Service Bulletin No: 30-007

Modification No: EC-24-0351

**ICE AND RAIN PROTECTION - WINDOWS, WINDSHIELDS AND DOORS  
MODIFICATION TO REPLACE THE LH WINDSHIELD HEATING SOLID STATE RELAY****1. Planning information****A. Effectivity**

PC-24 aircraft MSN 101 thru MSN 337 that HAVE embodied SB 30-004 or SB 30-006 at the Initial Issue.

MSN 101 thru MSN 337 - Replace the LH Solid State Relay  
Figure 1 (Sheet 1 of 9)

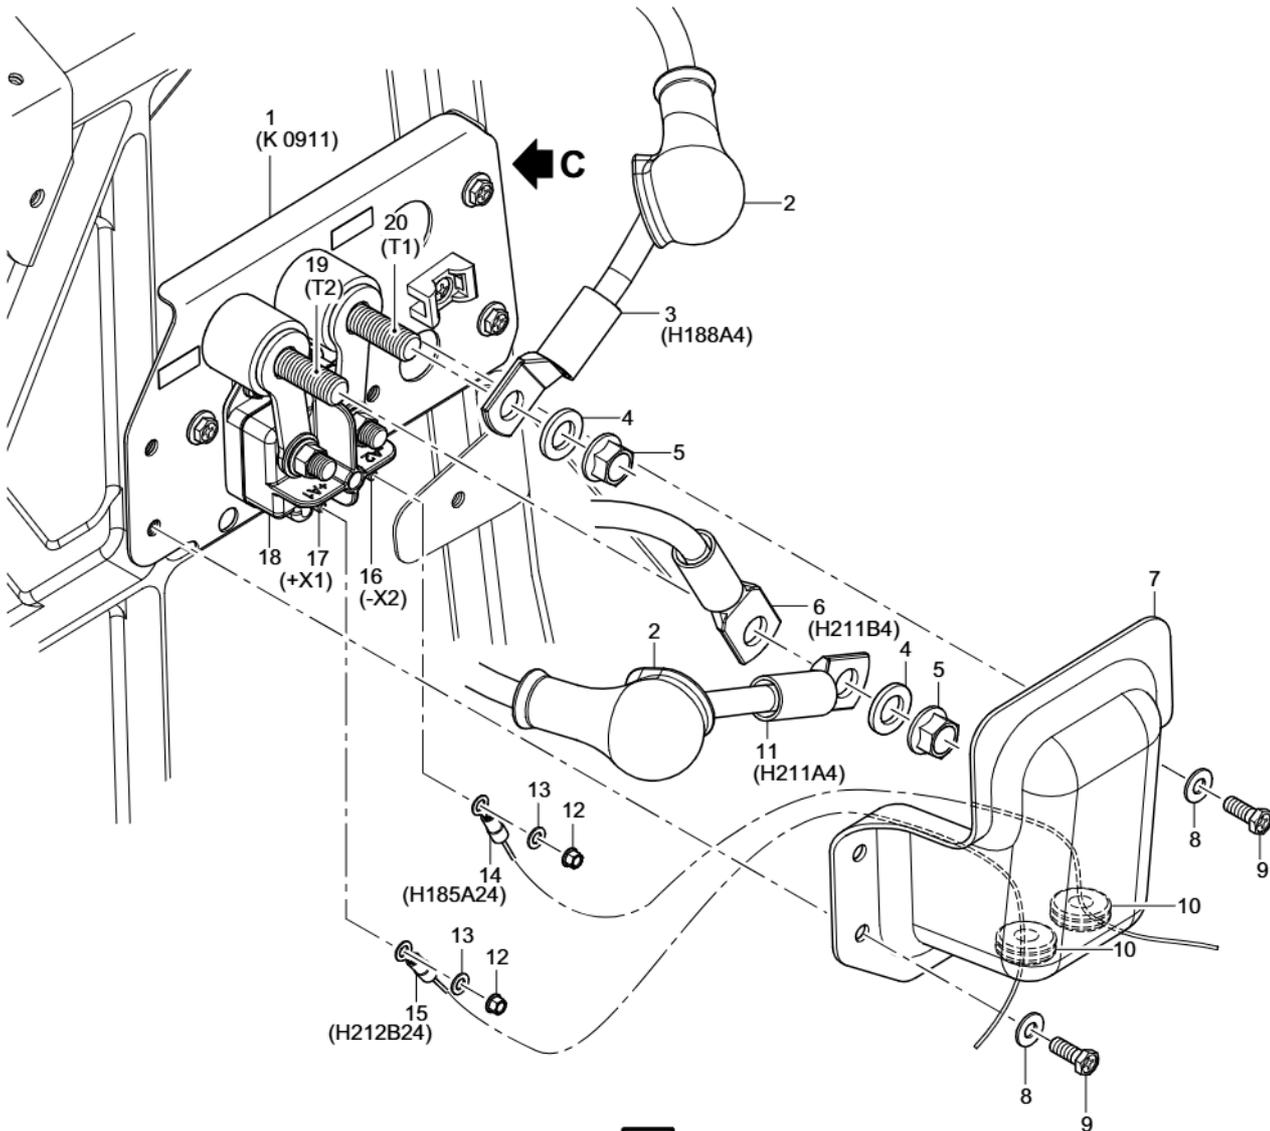
- Keep the screw (68)
  - Discard the washer (69).
- (o) Remove (and discard) the clamp (70) from the norm de-ice feeder cable H211B4 (6) and the LH de-ice feeder cable H196A4 (43).  
Refer to Figure 1 (Sheet 1 and 8, View A and N (Pre SB)).

Refer to Figure 1 (Sheet 1 and 8, View A and M).

- (aa) Put the new saddle (71) (P/N 971.32.18.122) in position on the structure near the SSR (29). Refer to Figure 1 (Sheet 1 and 8, View A and N (Post SB)).

MSN 101 thru MSN 337 - Replace the LH Solid State Relay  
Figure 1 (Sheet 2 of 9)

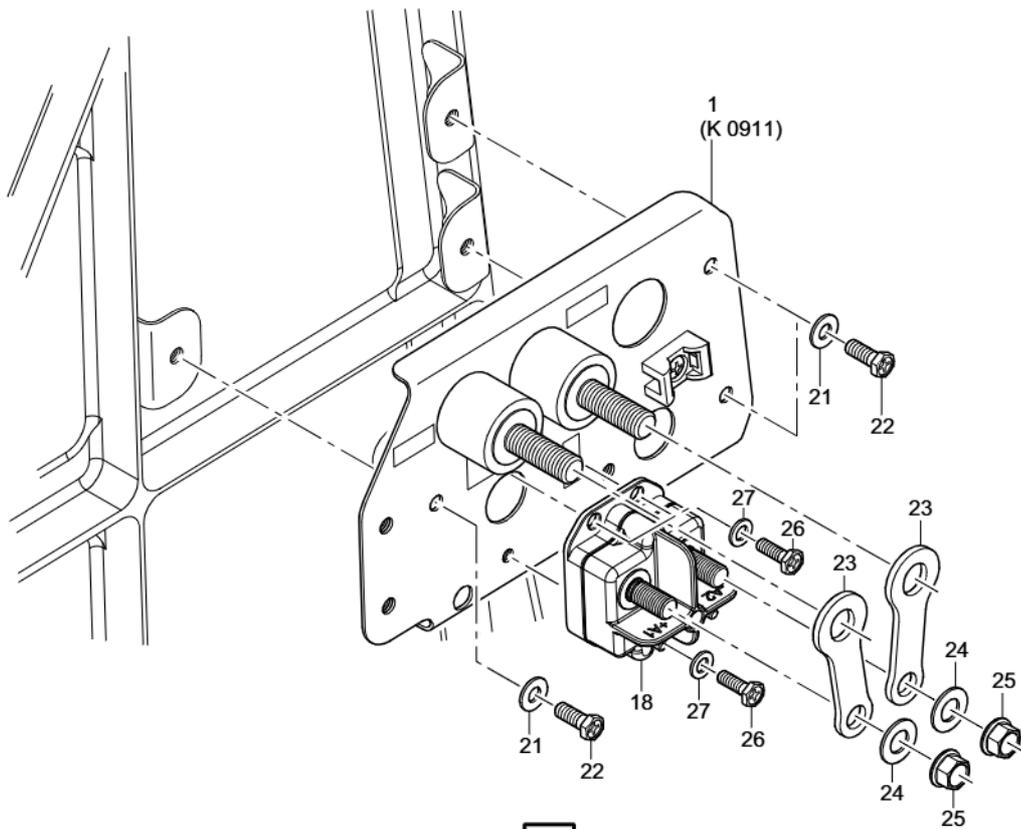
- (1) Remove the LH Solid State Relay (SSR) (18):  
Refer to Figure 1 (Sheet 2 and 3)
  - (a) Remove (and discard) the four screws (9) and the four washers (8) that attach the cover (7) to the contactor panel K 0911 (1).

MSN 101 thru MSN 337 - Replace the LH Solid State Relay  
Figure 1 (Sheet 4 of 9)

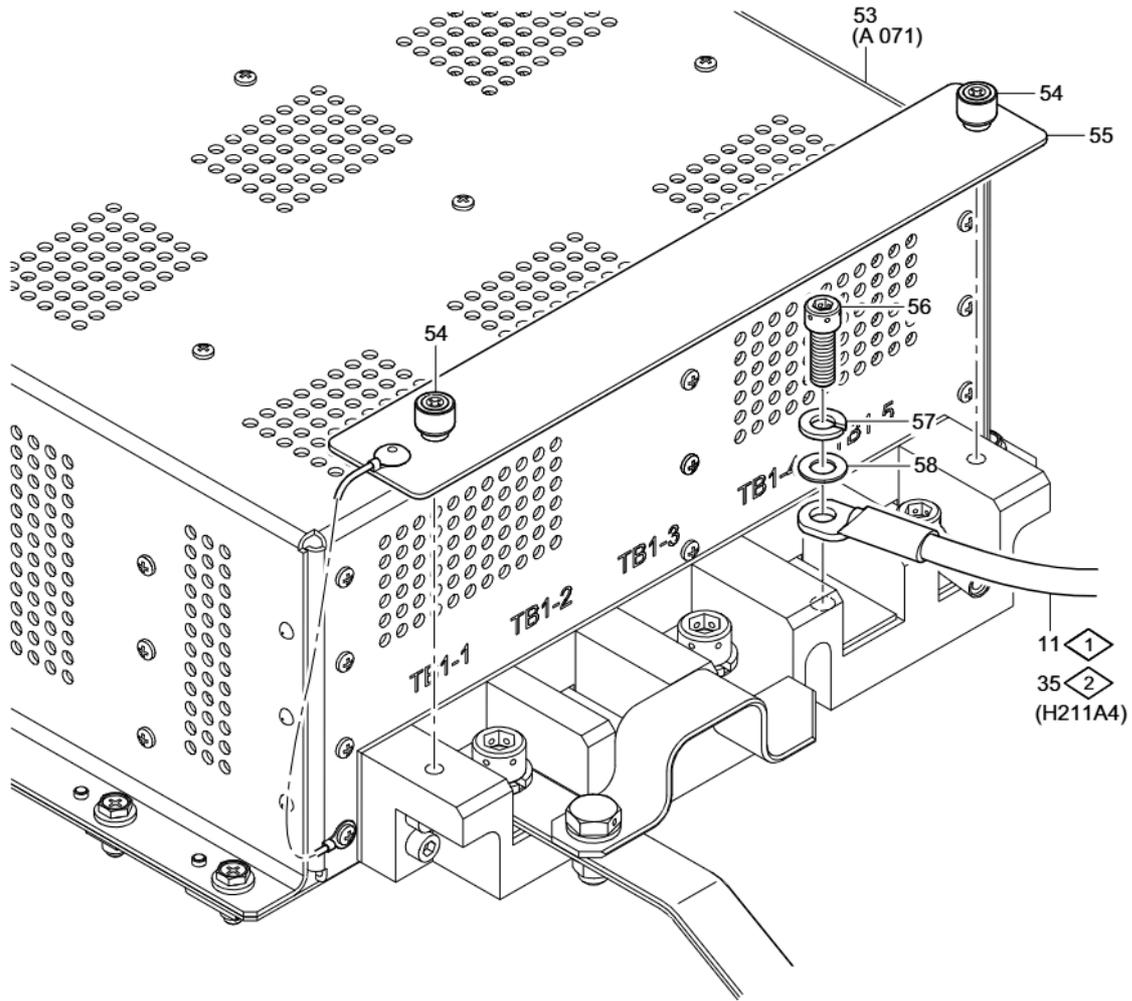
- (3) Install the new LH SSR (29):  
Refer to Figure 1 (Sheet 4)

- (k) Install the placard (32) on the contactor panel K 0911 (28):
- 1 Clean the area where the new placard K 0911 (32) (P/N 511.35.24.941) is to be installed with absorbent paper (Material No. P02-031) made moist with isopropyl alcohol (Material No. P01-011). Refer to Figure 1 (Sheet 4, View C).

MSN 101 thru MSN 337 - Replace the LH Solid State Relay  
Figure 1 (Sheet 9 of 9)

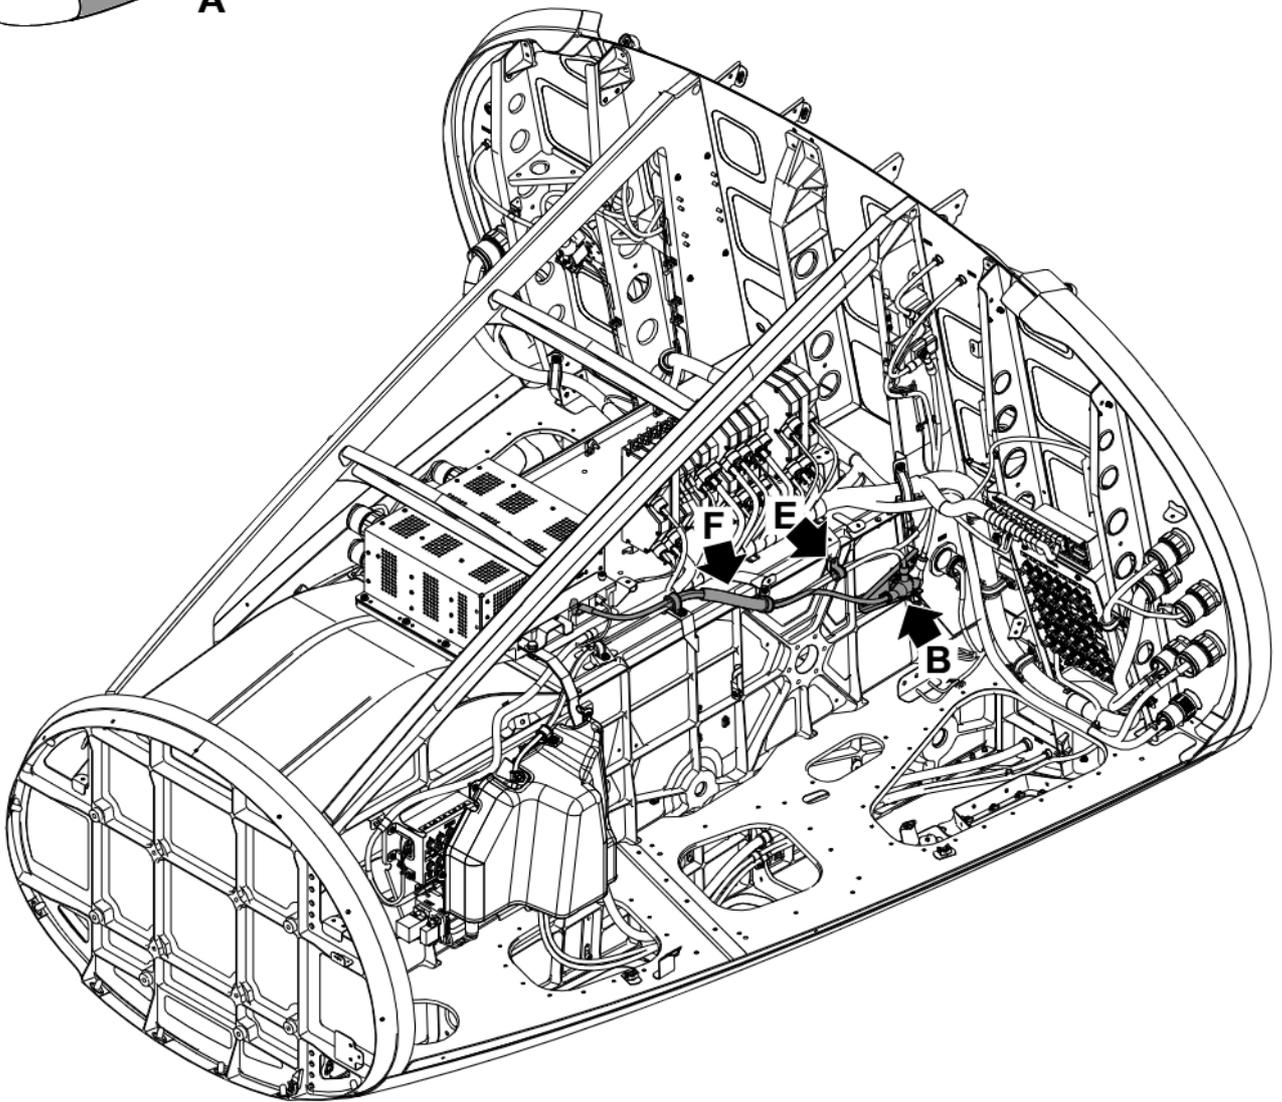
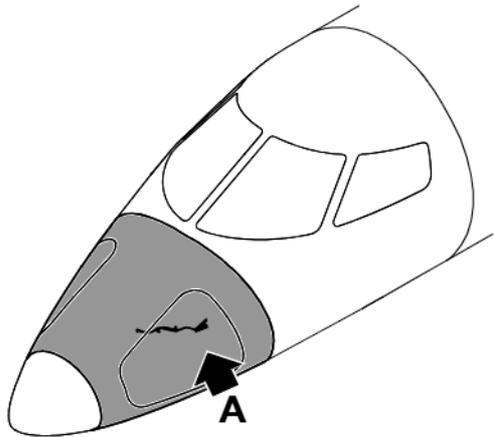
- (l) Loosely route the new norm de-ice feeder cable H211B4 (34) (P/N 591.50.24.099):
  - Thru the protective sleeve (72)  
Refer to Figure 1 (Sheet 1 and 9, View P)

- Thru the protective sleeve (72)  
Refer to Figure 1 (Sheet 1 and 9, View P)
  - Between the LH SSR (29) and terminal TB1-4 on the EPDU 1 (A 071) (53).

MSN 501 thru MSN 590 - Replace the LH Solid State Relay  
Figure 2 (Sheet 1 of 5)

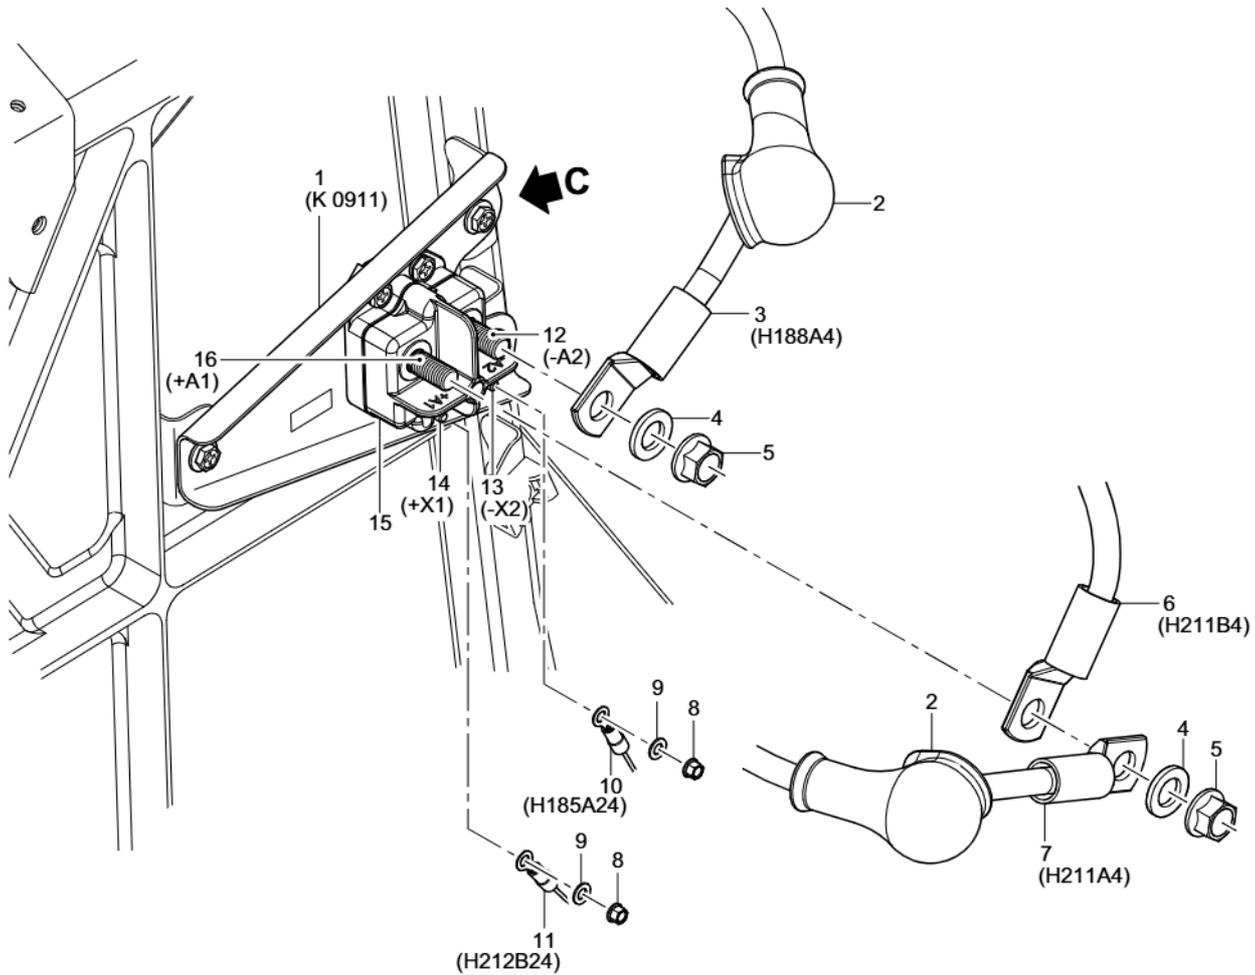
The windshield de-fog (or low power windshield heating) is switched ON/OFF by the LH Solid State Relay (SSR) (P/N 974.20.01.234). When this MOSFET-type SSR is in the OFF state, electrical current is allowed to flow in the reverse direction.

Replace the LH SSR (P/N 974.20.01.234) with the new LH SSR (P/N 974.20.01.235). The new LH SSR does not allow unintended reverse current flow.

MSN 501 thru MSN 590 - Replace the LH Solid State Relay  
Figure 2 (Sheet 2 of 5)

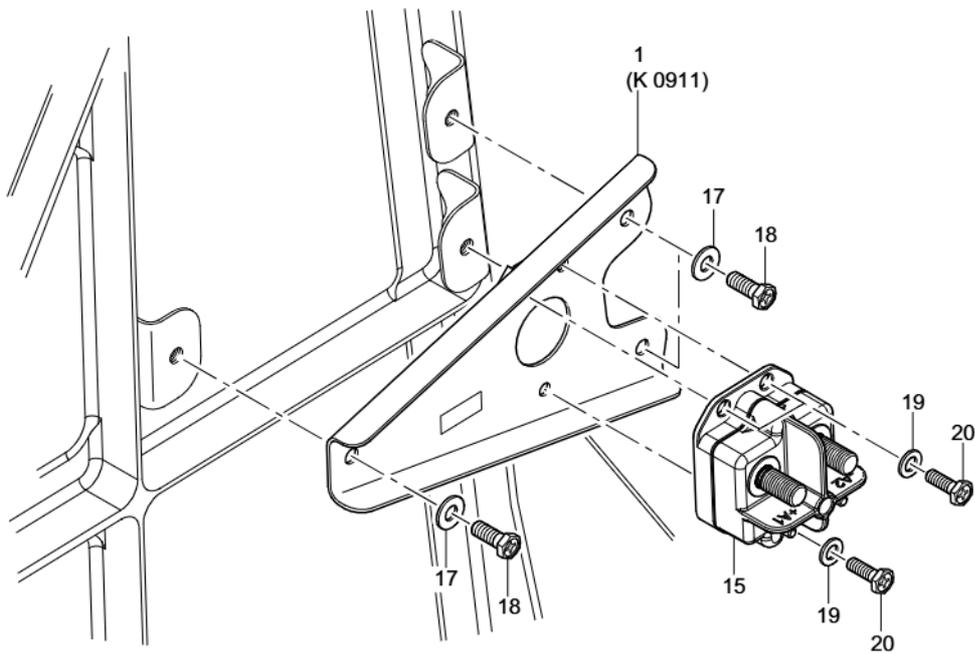
- (1) Remove the LH Solid State Relay (SSR) (15):  
Refer to Figure 2 (Sheet 2 and 3)
  - (a) Remove (and keep) the nut (8) and the washer (9) from terminal +X1 (14) on the SSR (15).

MSN 501 thru MSN 590 - Replace the LH Solid State Relay  
Figure 2 (Sheet 4 of 5)

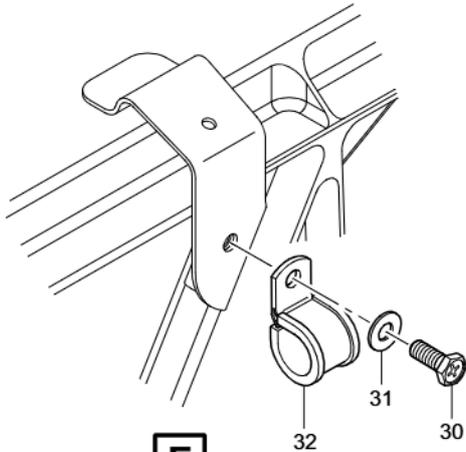
- (2) Install the new LH SSR (22):  
Refer to Figure 2 (Sheet 4 and 5)
- (a) Clean the mating surfaces for electrical bonding on the:
- Structure
  - New contactor panel K 0911 (21) (P/N 524.60.24.144)

- 1 Clean the area where the new placard K 0911 (25) (P/N 511.35.24.941) is to be installed with absorbent paper (Material No. P02-031) made moist with isopropyl alcohol (Material No. P01-011). Refer to Figure 2 (Sheet 4, View C).
- 2 Let the area dry.
- 3 Remove the backing strip from the new placard K 0911 (25).
- 4 Install the new placard K 0911 (25) in position on the contactor panel K 0911 (21). Make sure that no air bubbles are caught between the placard and the surface.

MSN 501 thru MSN 590 - Replace the LH Solid State Relay  
Figure 2 (Sheet 5 of 5)

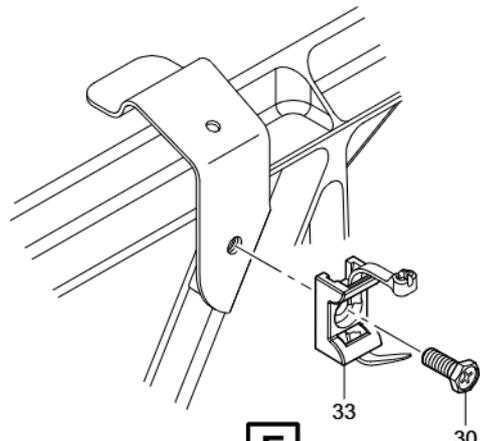
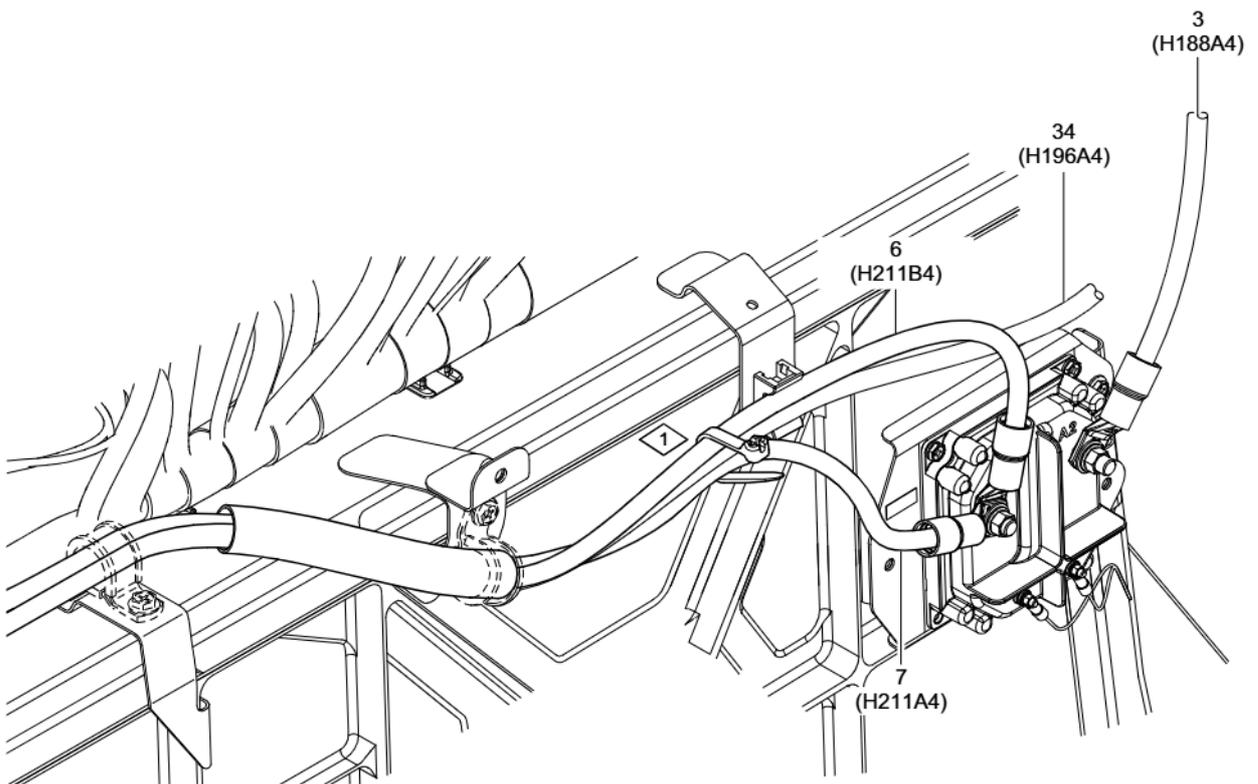
- (o) Remove the clamp (32):  
Refer to Figure 2 (Sheet 5, View E (Pre SB))
- 1 Remove the one screw (30) and washer (31) that attaches clamp (32) to the structure near the SSR (15) installation position:

- (l) Install the saddle (33):  
Refer to Figure 2 (Sheet 5, View E)

Refer to Figure 2 (Sheet 5, View F).

- (m) Make bends in the feeder cable H211A4 (7), as necessary, so that the terminal lug can be installed on terminal A1 (28) of the LH SSR (22). Refer to Figure 2 (Sheet 5, View F).
- (n) Use an applicable cable tie (Material No. P09-140) to attach the feeder cable H211A4 (7) to the other cable(s) H211B4 (6) and H196A4 (34). Refer to Figure 2 (Sheet 5, View F and Flag Note 1).
